Robin Partington & Partners
built around people

Non-material Amendment April 2016

Parker House Addendum Statement

This report sets out a number of technical issues identified within the consented Parker House scheme, and the proposed responses and design solutions that together form this NMA application. This follows a Pre-Application meeting with Camden Council which was held on 23rd March 2016, and attended by planning and design officers. It was agreed that the revisions were non-material in principle, subject to adequate technical and design justification.

Section Facing Rear

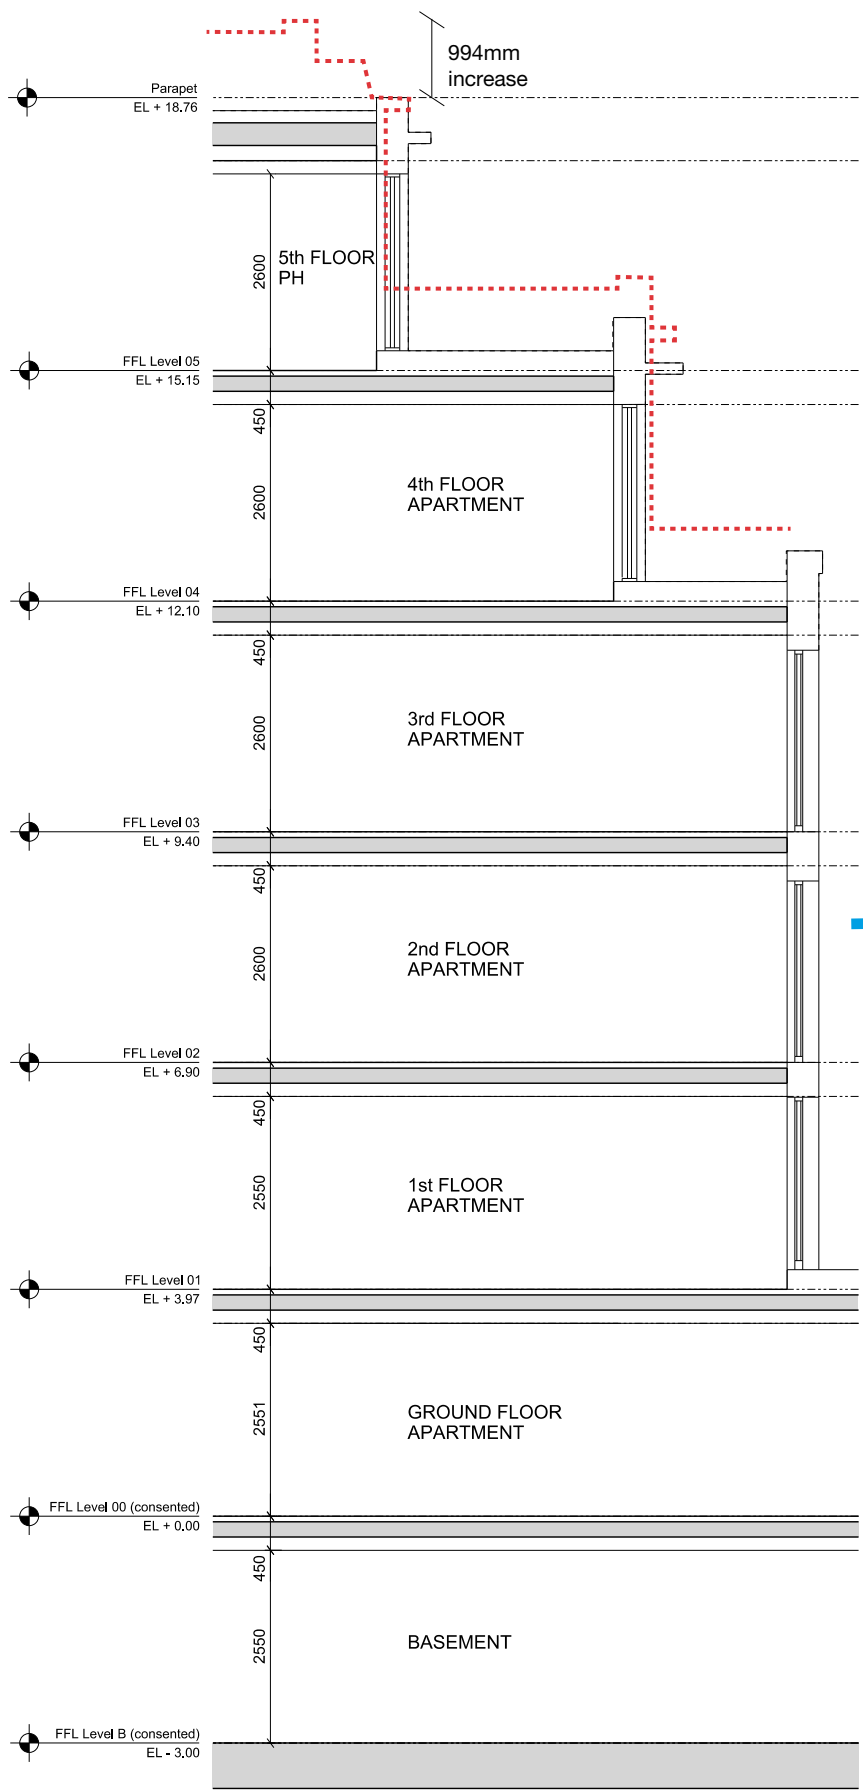
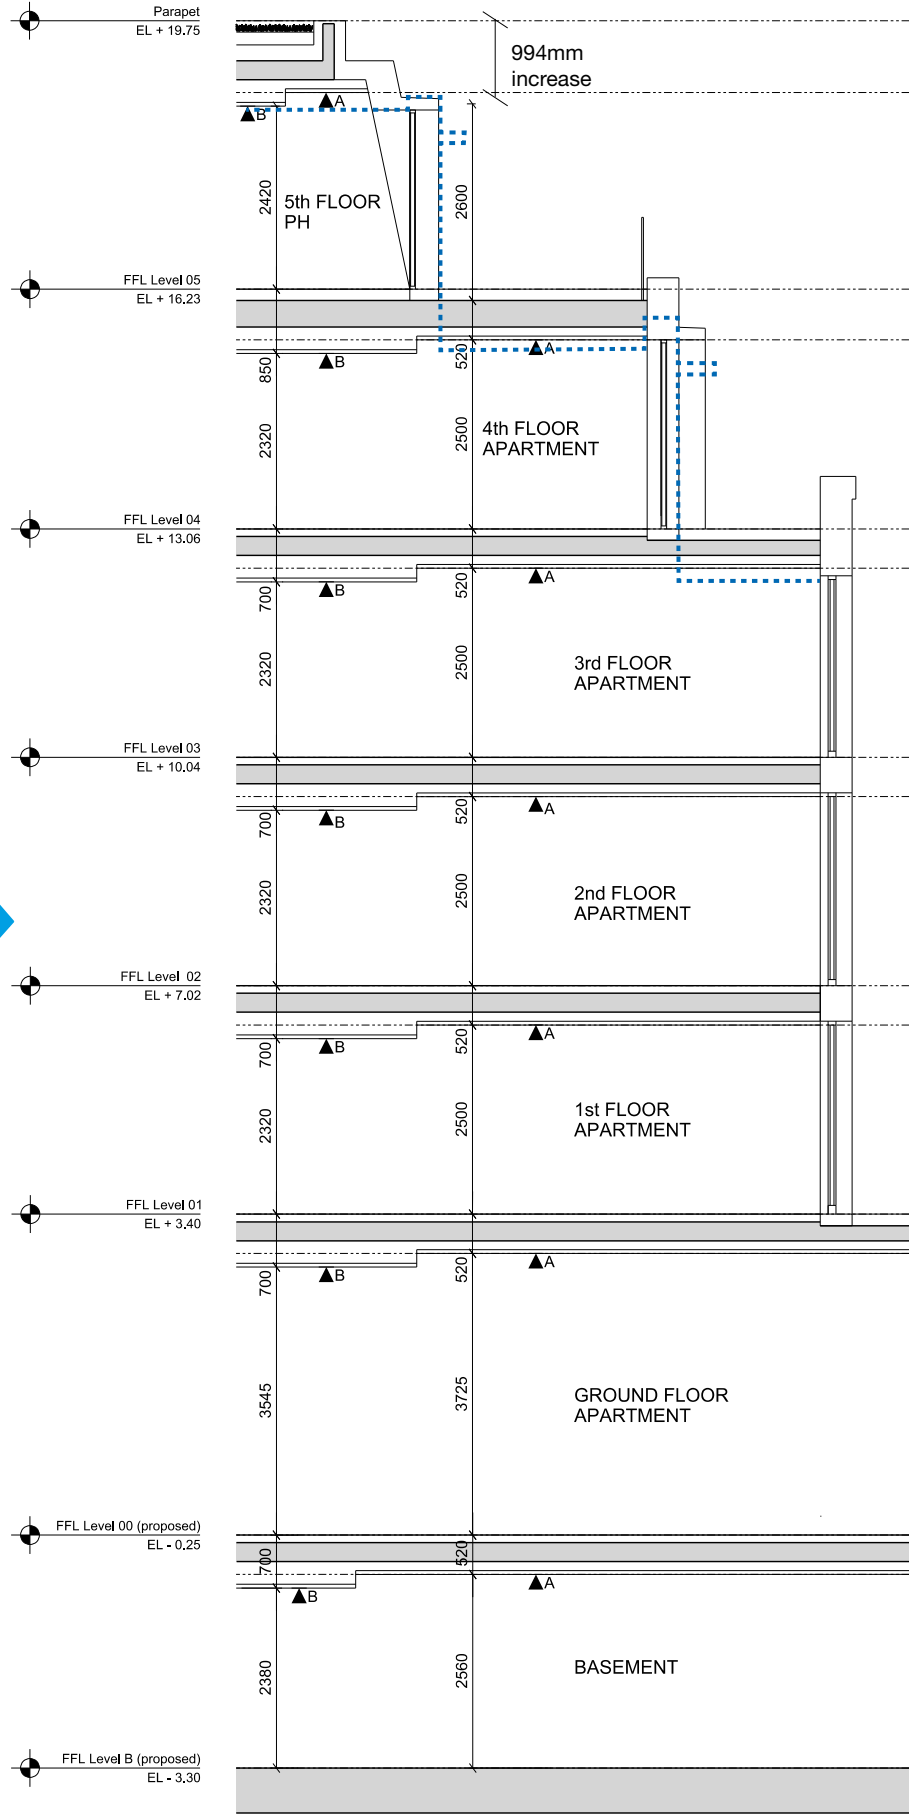
- Consented section on left hand side demonstrates the floor build ups and ceiling heights within the approved scheme.
- As demonstrated on page 10, floor build ups have been undersized and do not meet minimum requirements. Once minimum floor build ups are considered, ceiling heights are further compromised.
- Proposed section on right hand side demonstrates result of considering minimum floor build ups, and consistent ceiling heights of 2320mm-2500mm (depending on ceiling void condition) across floors 1-4, and 2420mm-2600mm in Penthouse.
- Proposed ceiling heights do not exceed consented ceiling heights (other than those that were described as 'compromised'), and remain acceptable and compliant with relevant design guidance.
- Profile of roof parapet has been revised so as not to impact on Parker Street. This includes stepping back the roof parapet, and reducing the depth of the canopy.

DETAIL E - Top Level Parapet With Green Roof
- Facing Parker Street

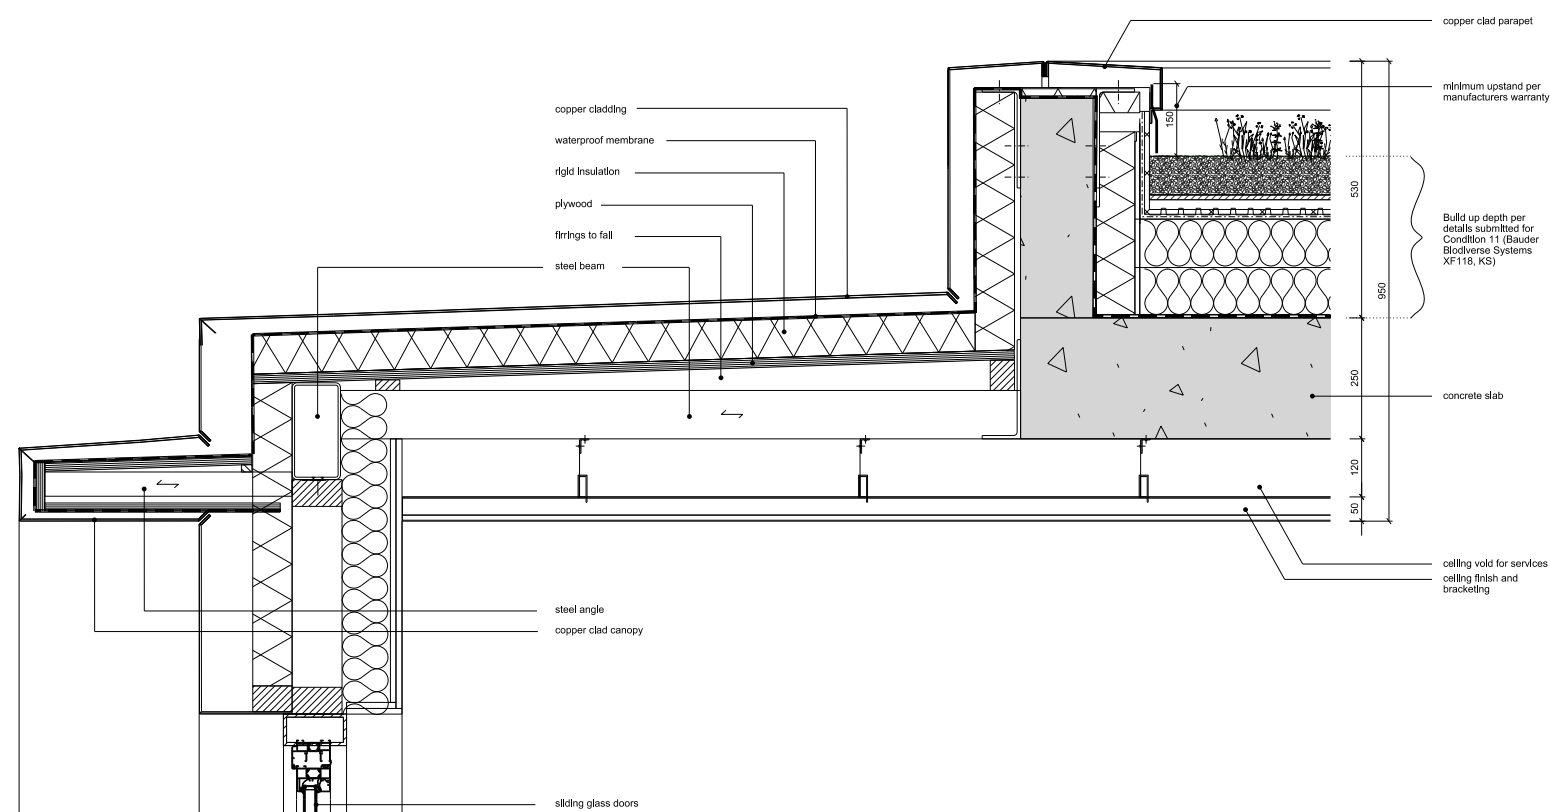
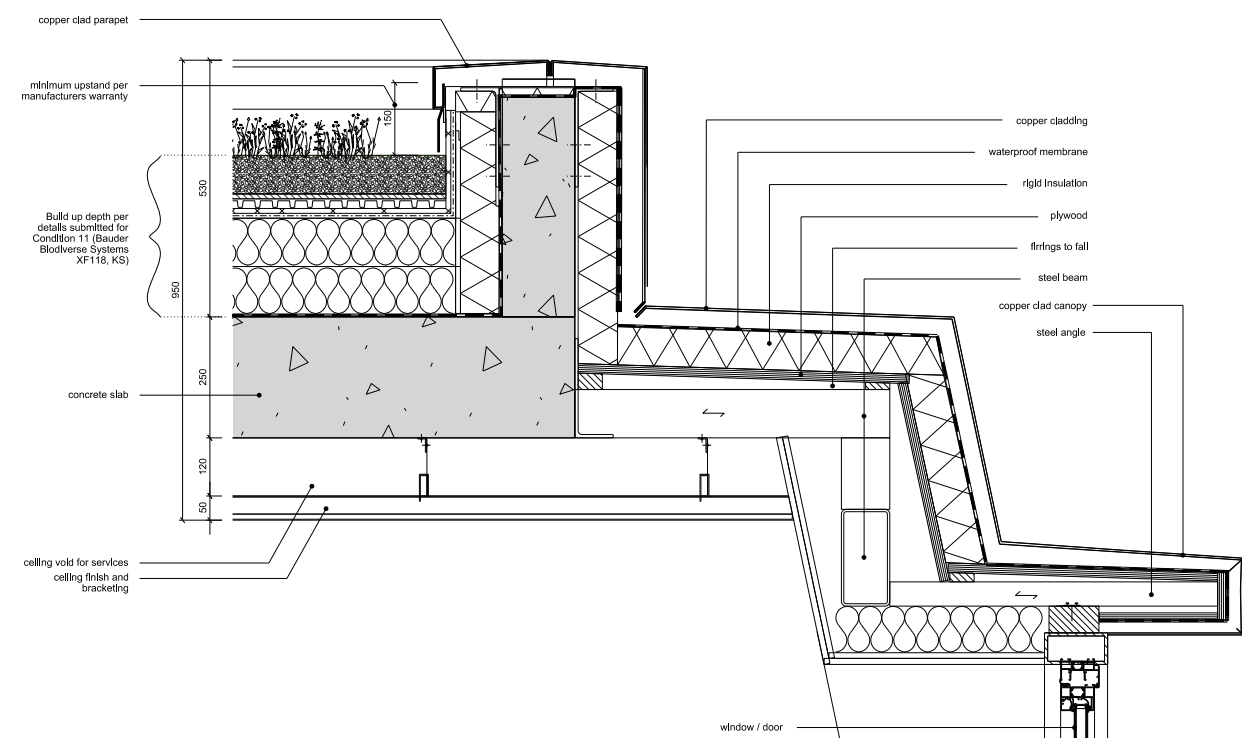
- Details E and F demonstrate minimum build up within profile of parapet.
- A minimum of 150mm upstand above the green roof is required to ensure warranty from the manufacturers of the waterproofing membrane.
- Build up of extensive green roof is as per details (submitted) for Condition 11 requirements.
- Parapet, external walls and canopy to be clad in copper, as consented.

PROPOSED FOURTH FLOOR PLAN

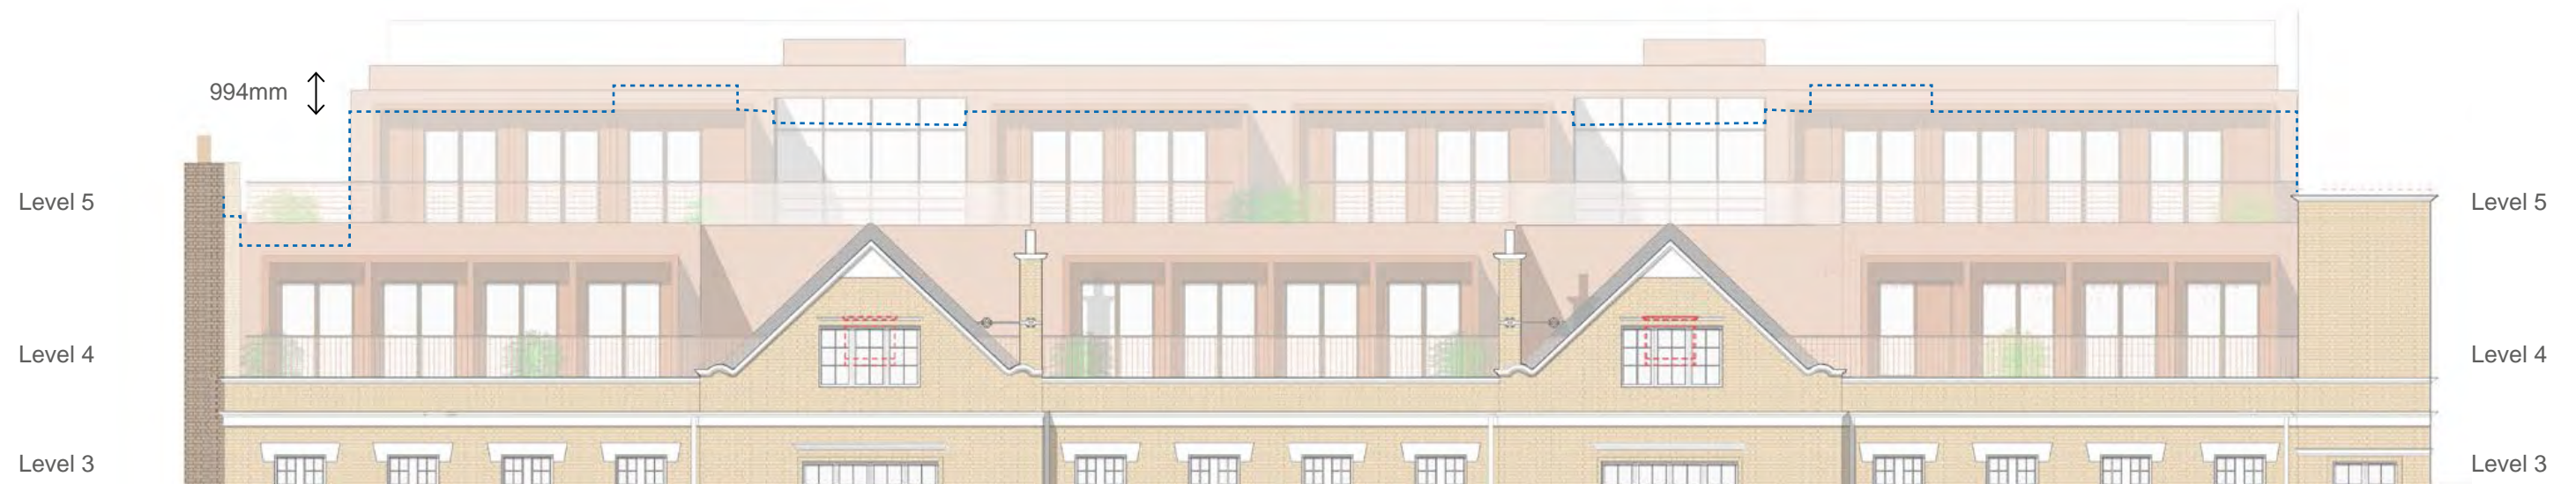
• Fourth floor plan of proposed scheme demonstrates that recessing the front wall of the fourth floor by 531mm does not compromise the layout of the apartments.

CONSENTED GROUND FLOOR PLAN

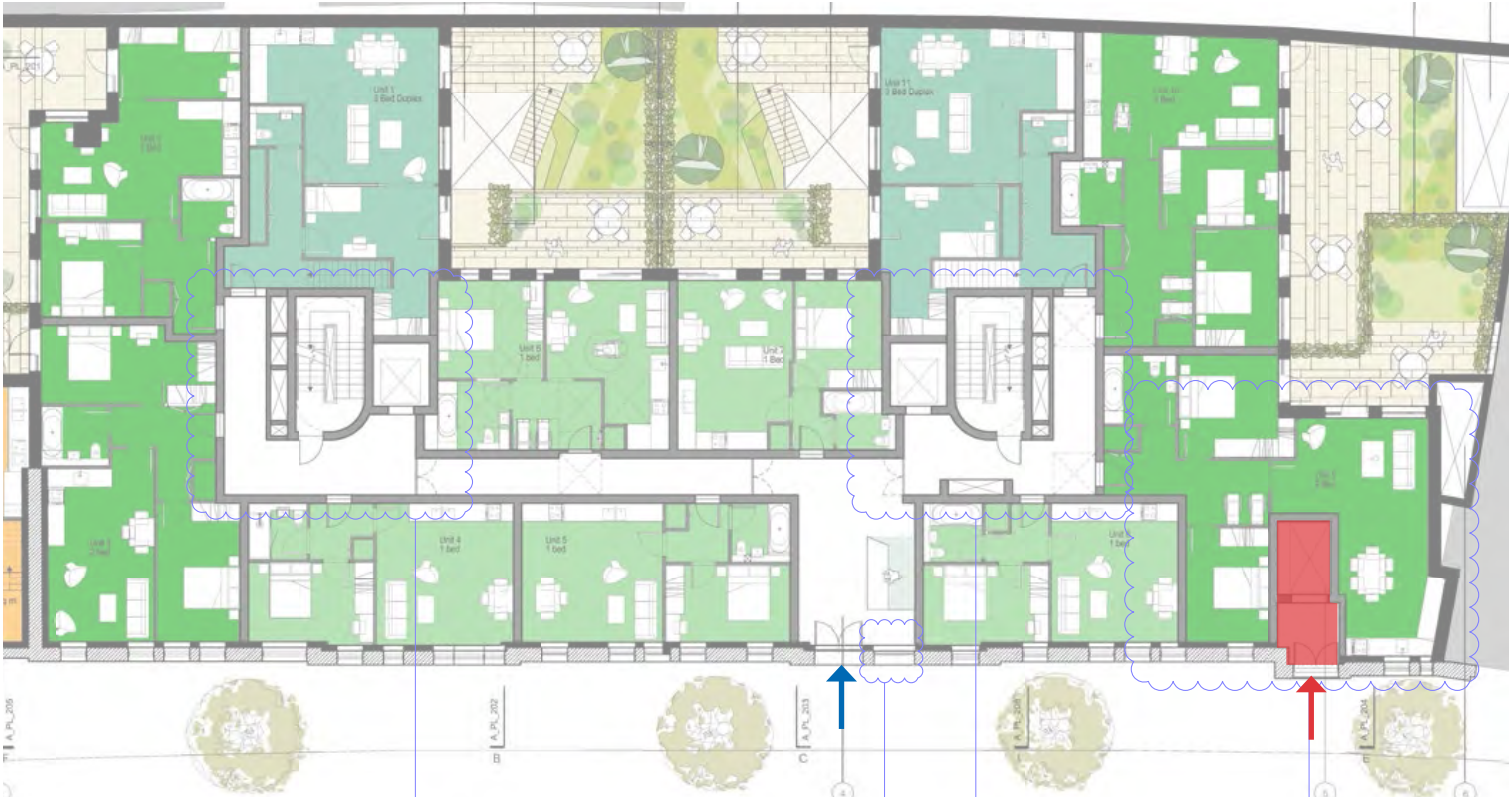
- In the consented scheme access to the basement for cycles, waste and plant replacement is through the front door, and using one of the two passenger lifts that has been oversized.
- The bins are moved upstairs and downstairs through a service lift that is located immediately adjacent to the front door. A concern has been raised over this proximity which may compromise residential quality.

- The proposal is to have a remote service lift dedicated to cycles, bins and plant located away from the front door. This will be in place of an existing door and window at the base of the water tower. (please refer to the front elevation on page 16)

- By enlarging the existing door the following points can be achieved:
 - Mechanical equipment in the basement plant areas can be replaced via the service lift and door on the front facade. If the door is not enlarged, this equipment can only be replaced by removing part of the terrace slab in one of the private gardens, and craning the equipment over the building. This was identified as a health and safety concern by the Principal Designer.

- Use of standard sized Eurobins. With the smaller opening, a larger number of samller bins would be required.
 - Having a seperate access to the cycle store directly from the street, and without pushing the bikes through the reception/concierge area.
